Customer Complaint Notification — e-coat appearance / corrosion protection

Complaint no.	C-OEMN-2026-0327	Date issued	2026-09-23
Supplier	Componentes Arga S.L.	Supplier code	ARGA
Supplier part no.	AR-1009	OEM drawing no.	ON-118870 rev. B (fictitious)
Special characteristic	E-coat thickness (SC)	Quantity NOK (confirmed)	60
Supplier lot (label)	L26250-AR1009-01	Suspect qty delivered	1,580 pcs
Supplier delivery notes	AL-26-00562 — 790 pcs, shipped 2026-09-13 AL-26-00563 — 790 pcs, shipped 2026-09-16	Detected at	OEM Norte cooling module line, incoming audit and paint lab
Part description	Low-temperature radiator bracket	Repeat indicator	POSSIBLE — e-coat porosity complaint on this part no. in 2024 (our ref. C-OEMN-2024-0163)

Fig. 1 — Rear face of a NOK part: craters next to the MIG seam (scale bar 10 mm).

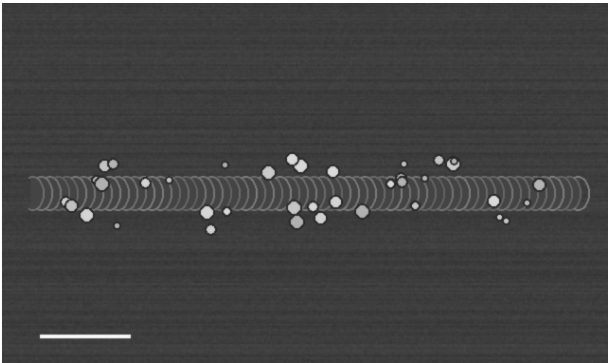
Incoming audit on 2026-09-22 found **pores and craters in the e-coat** of low-temperature radiator brackets from lot **L26250-AR1009-01**. After sorting the parts available at the cooling module line, **60 parts** are NOK. The craters are round, Ø 0.3–1.0 mm, some down to bare metal.

Fig. 2 — Distribution of the craters found on 10 NOK parts (schematic).

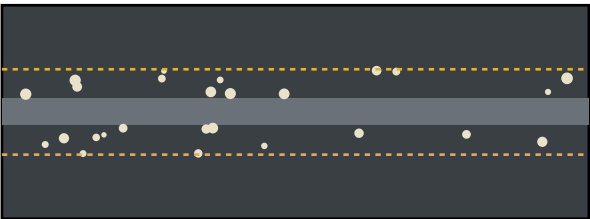
Observation (OEM Norte paint lab, report LAB-ON-26-4502)	Result
Location of craters	Along the MIG seam on the rear face and within ± 5 mm of it; 0 craters on flat areas outside that band
E-coat thickness, flat areas (5 points, 10 parts)	19–23 µm (requirement 18–25 µm)
E-coat thickness at crater rim	4–8 µm
EDX at crater centre (3 craters)	Si, Mn and O detected (glassy residue); P and Zn not detected
Adhesion (cross-cut) on flat areas	Gt 0 — conform
Neutral salt spray 480 h	Started 2026-09-22 on 5 parts; result pending (expected 2026-10-12)

rear face — MIG seam and ± 5 mm band (dashed)

flat areas outside the band: no craters found
